<u>PROJECT ADDRESS</u>	9603 SE 61ST PL MERCER ISLAND, WA 98040
<u>PROJECT NUMBER</u>	TBD
<u>ASSESSOR'S PARCEL #</u>	4260000020
<u>LEGAL DESCRIPTION</u>	LOT 2 OF LELAND ADDITION, AS PER PLAT RECORDED IN VOLUME 82 OF PLAT, PAGE 19, RECORDS OF KING COUNTY AUDITOR; SITUATE IN THE CITY OF MERCER ISLAND, COUNTY OF KING, STATE OF WASHINGTON.
<u>PROJECT DESCRIPTION</u>	SCOPE INCLUDES A MAIN FLOOR ADDITION (173.53 SF) AND UPPER LEVEL ADDITIONS (493.71 SF) TO EXISTING SINGLE-FAMILY HOME, INCLUDING INTERIOR ALTERATIONS PER PLAN. IN ADDITION, NEW 198 SF DETACHED MODULAR SHED TO BE ADDED PER PLAN.
<u>ZONE</u>	R-15
<u>BUILDING TYPE</u>	SINGLE FAMILY RESIDENCE

During the course of construction, extensive framing rot was encountered and a few alterations were made as a result of the need to re-frame those areas. We are proposing to alter the STAR atrium roof framing from a Gable to shed as part of the rebuild. The new roof form will be lower than the proposed building height as previously permitted and below the MAX allowable building height. Additional changes that occurred as a result of demo discovery and rot repair are using closed cell insulation throughout the roof cavity, new siding scope

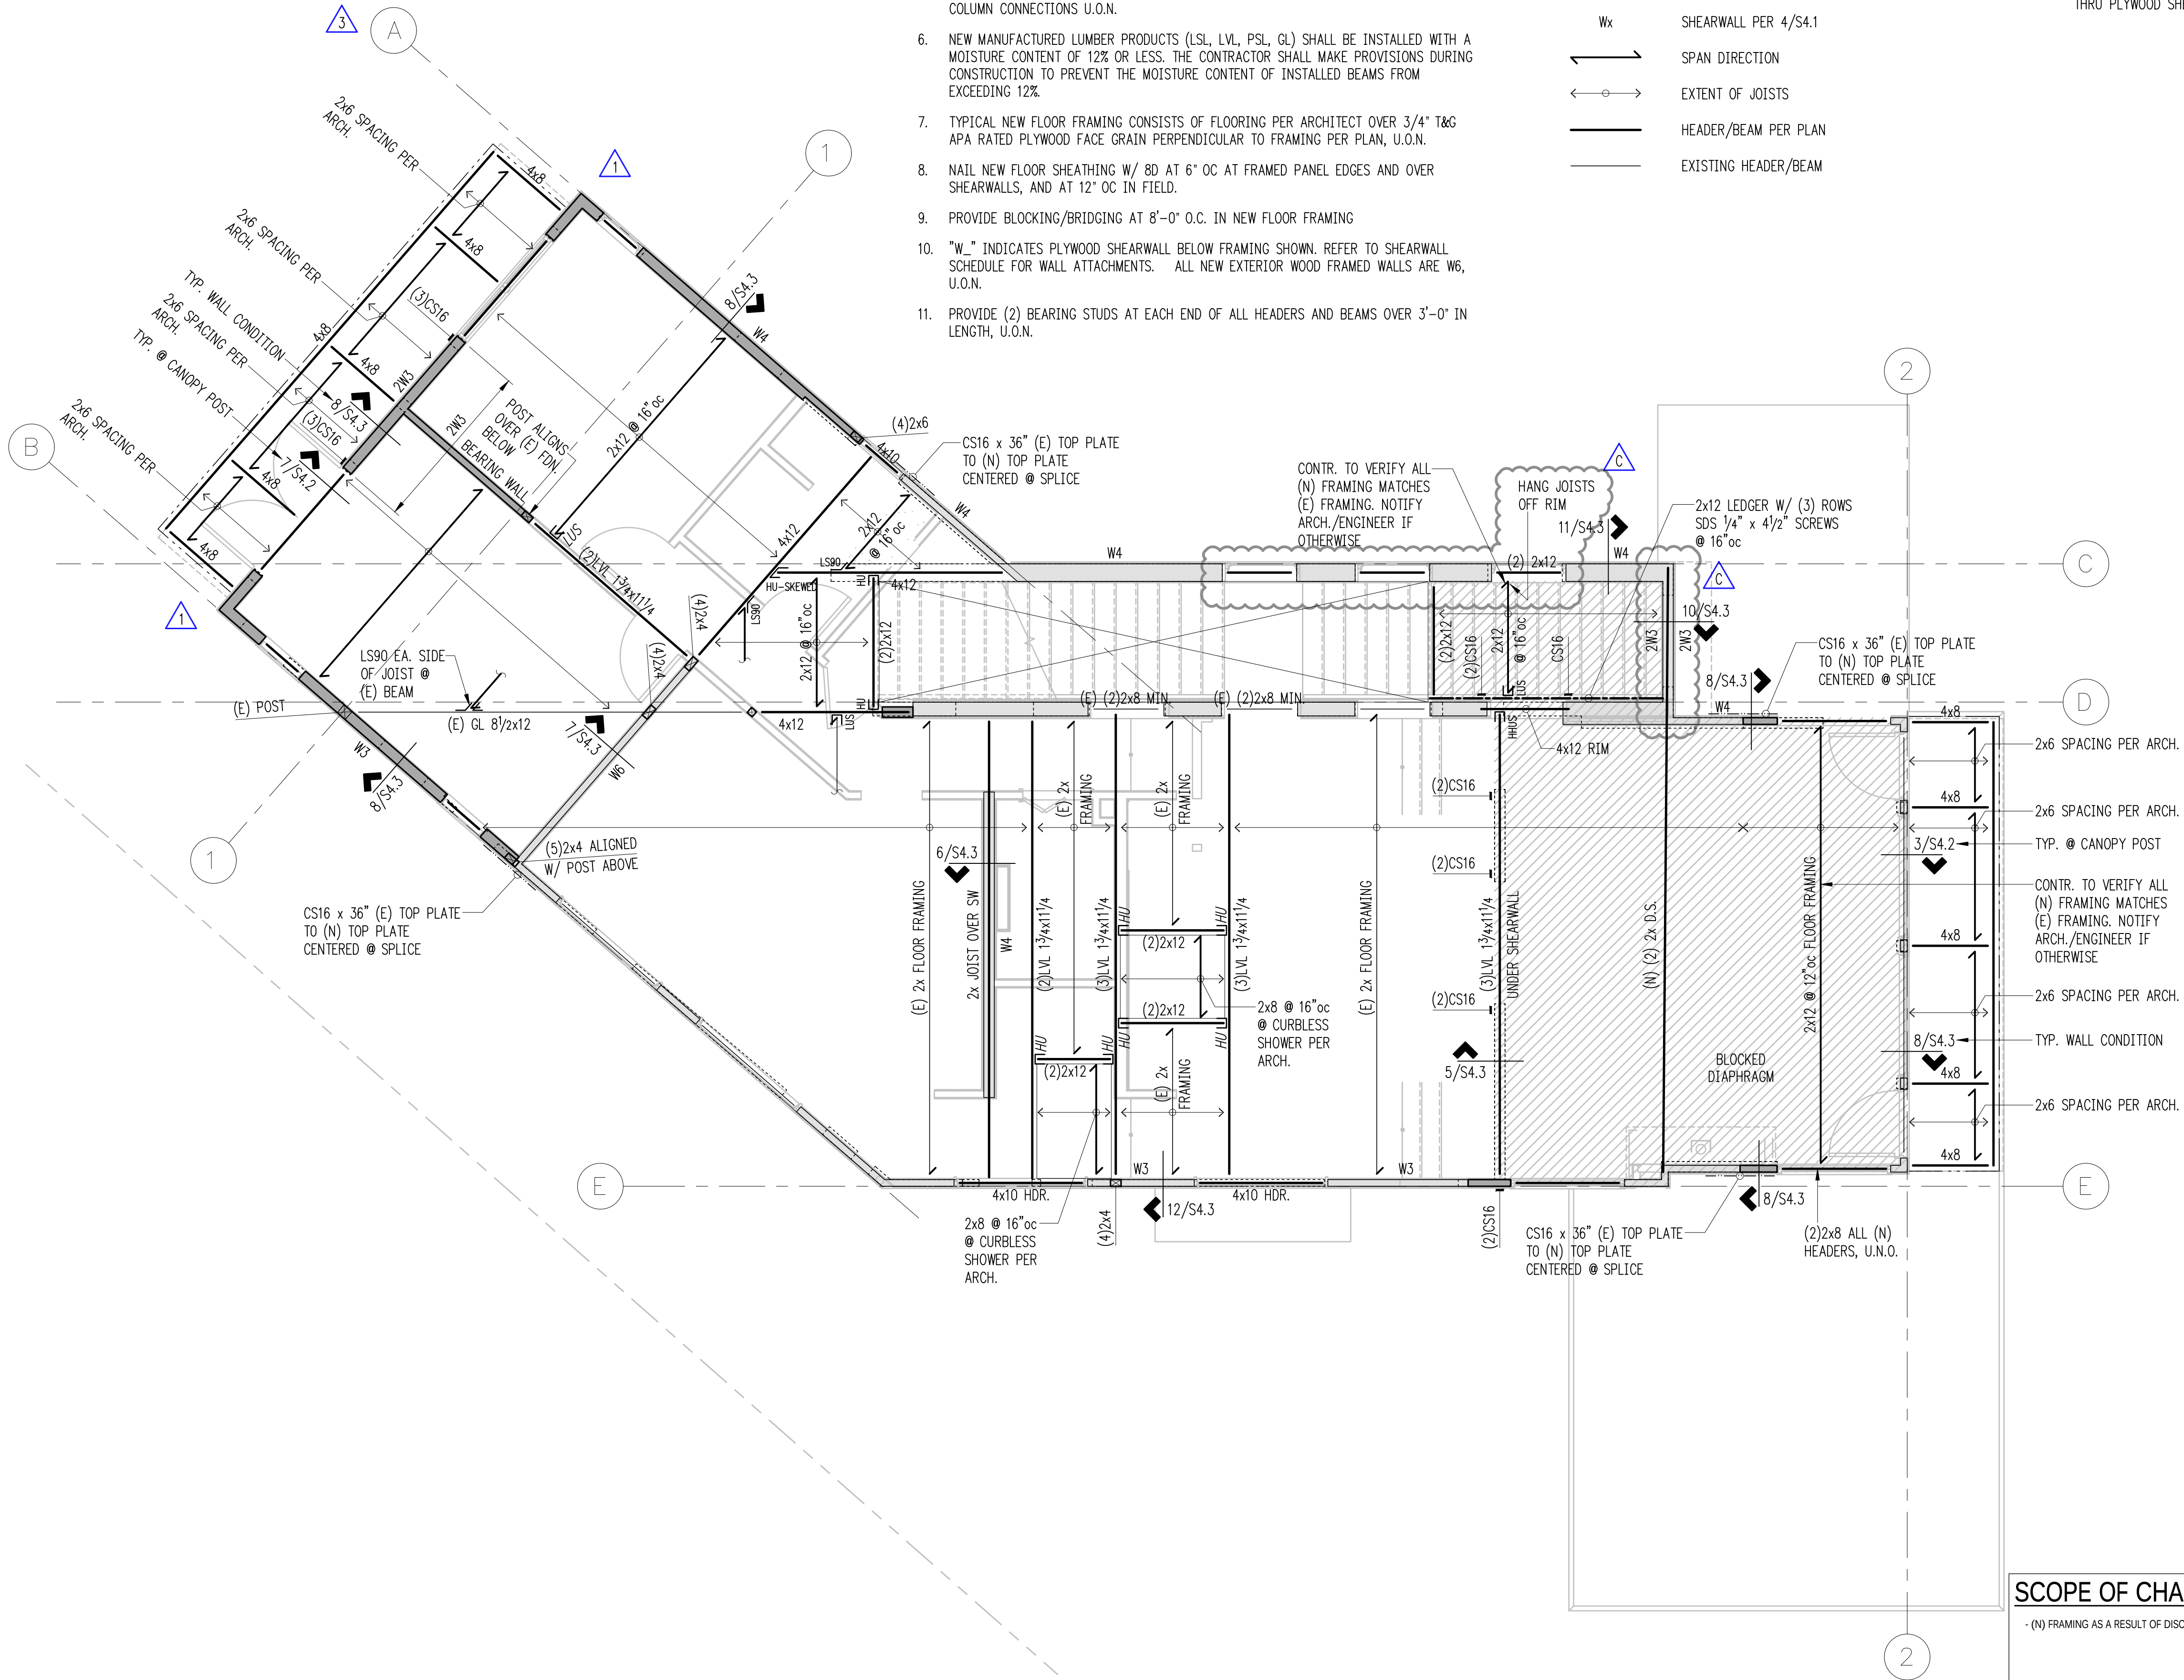
- (N) FRAMING AS A RESULT OF DISCOVERED ROT. REFER TO ARCH.

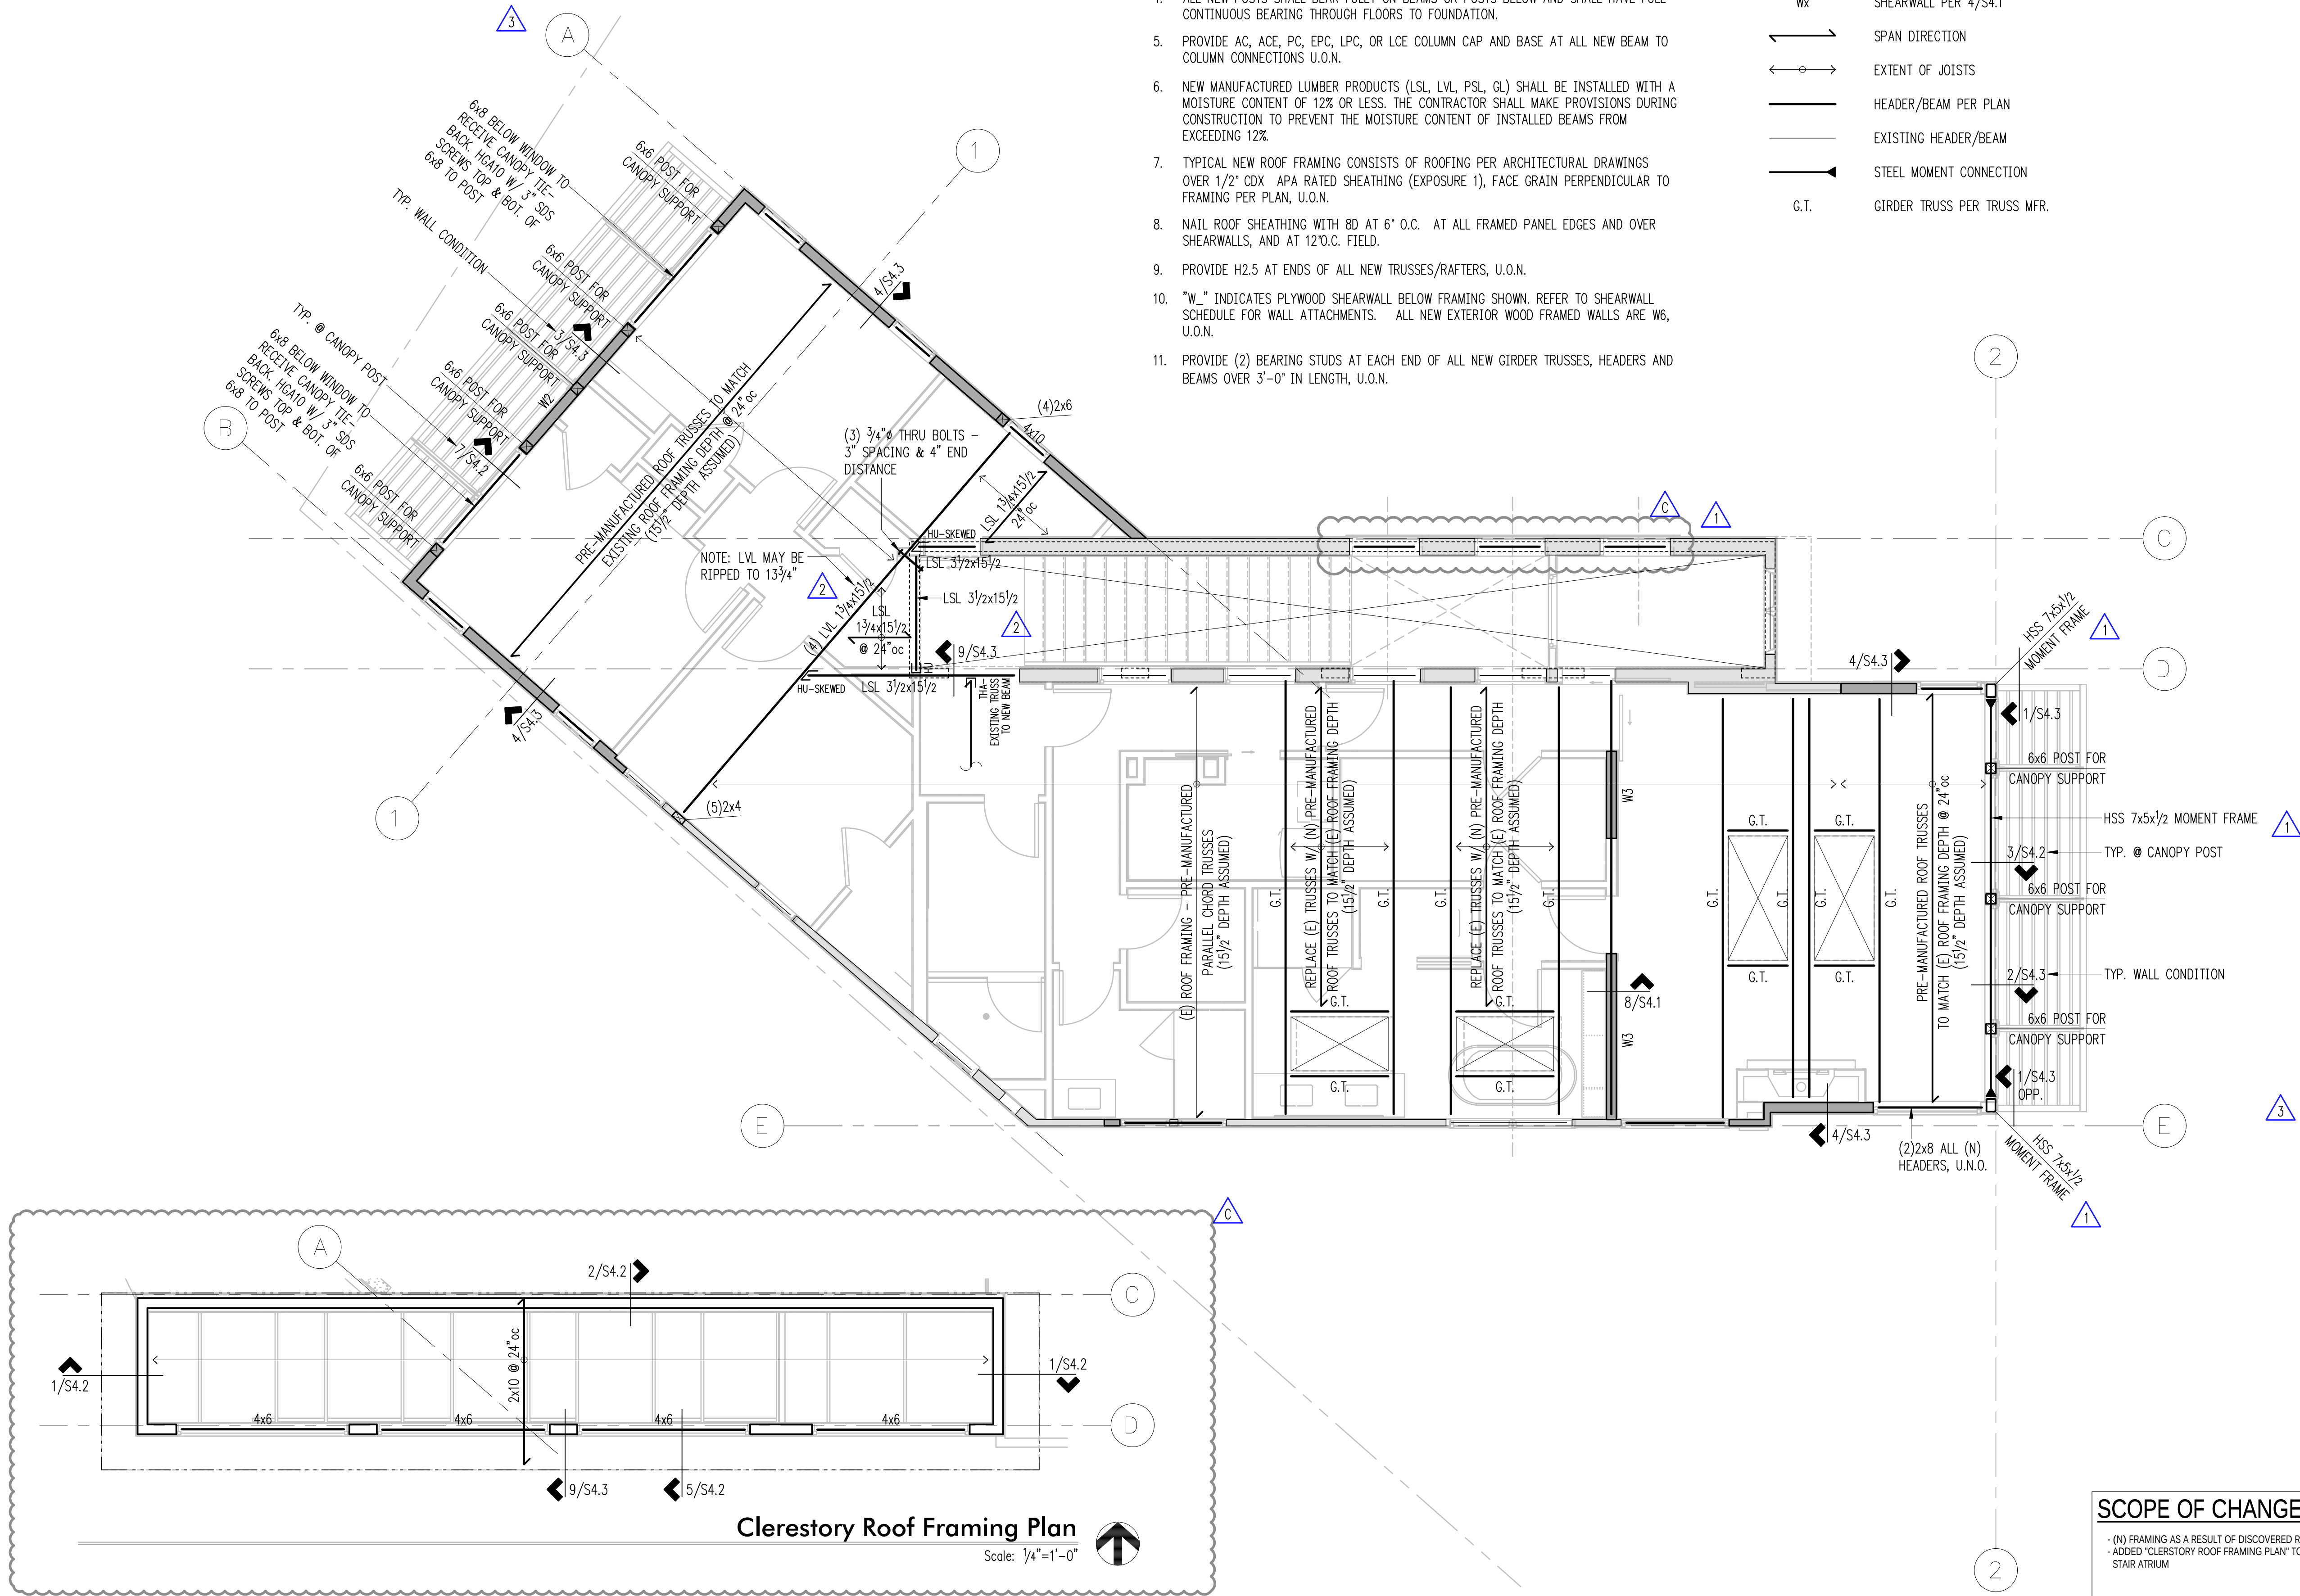
- (N) FRAMING AS A RESULT OF DISCOVERED ROT. REFER TO ARCH.
- ADDED "CLERESTORY ROOF FRAMING PLAN" TO SHOW WINDOWS ADDED IN STAIR ATRIUM
